SAFETY EVALUATION BY THE OFFICE OF NEW REACTORS
LICENSING TOPICAL REPORT MUAP-07006-P (REVISION 2)

"DEFENSE-IN-DEPTH AND DIVERSITY"

MITSUBISHI HEAVY INDUSTRIES, LTD.

Figure 2. RPS and ESFAS interface [Source: MUAP-07004-P, Rev. 2]

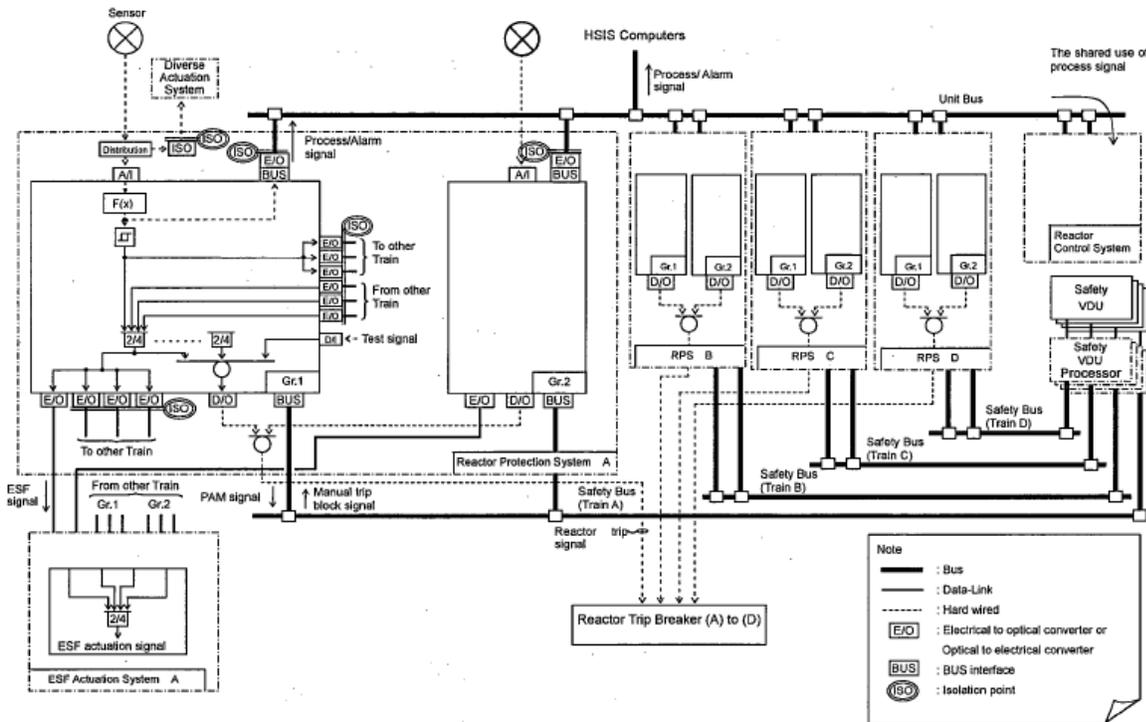
Sensor signals common to reactor trip and/or engineered safety feature actuation system (ESFAS) are transmitted to the reactor protection system (RPS) of the PSMS. The sensor signals are processed through setpoint comparison function blocks (bistables). There are separate bistables for each reactor trip and engineered safety feature (ESF) when there are differences in setpoint values. Bistable outputs from each train of the PSMS are combined using a 2-out-of-4 voting logic scheme. The voting logic outputs for a reactor trip are interfaced to the reactor trip breakers. The voting logic outputs for ESF actuation are transmitted to the ESFAS section of the PSMS.

Each ESFAS train processes the signals from all four respective trains in the PSMS divisions with 2-out-of-4 voting logic for the ESF actuation. Further description of the PSMS architecture is provided in Topical Report MUAP-07004-P, "Safety I&C System Description and Design Process," Revision 1.
